PCB-651

SCOPE OF BULLETIN:

Cylindrical decks now have an aluminum motor spacer plate

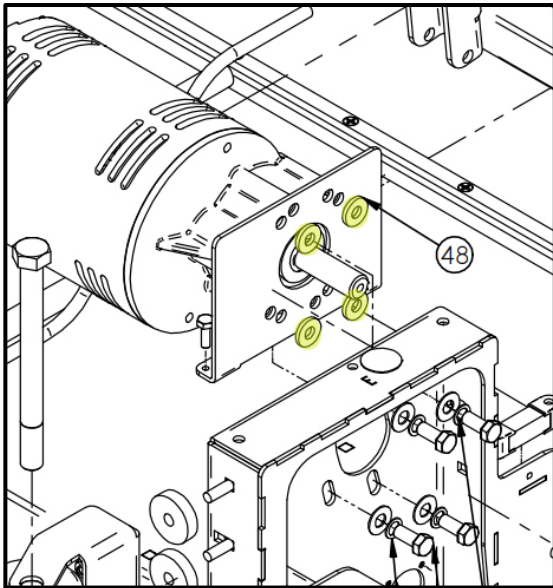
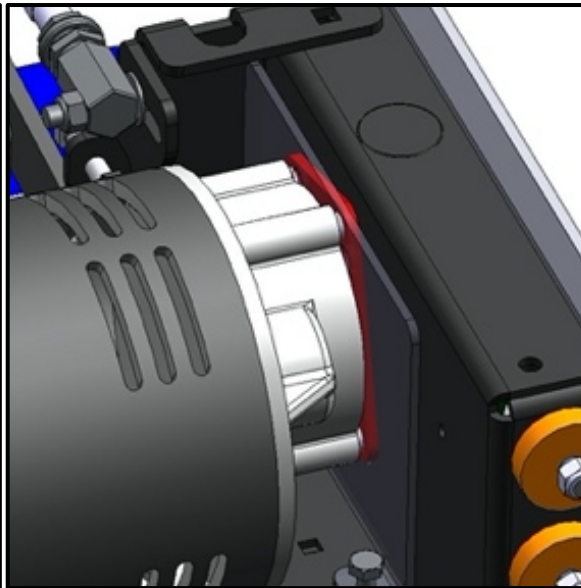
To speed up repairs, we have replaced the offset washers with a solid aluminum spacer plate that separate the Motor Height Adjustment Bracket and the Deck Wall.

(Old Washers in **YELLOW**)

(New Spacer Plate in **RED**)

If you wish to replace washers with new aluminum spacer plate, order **Part #: 650-9004**.
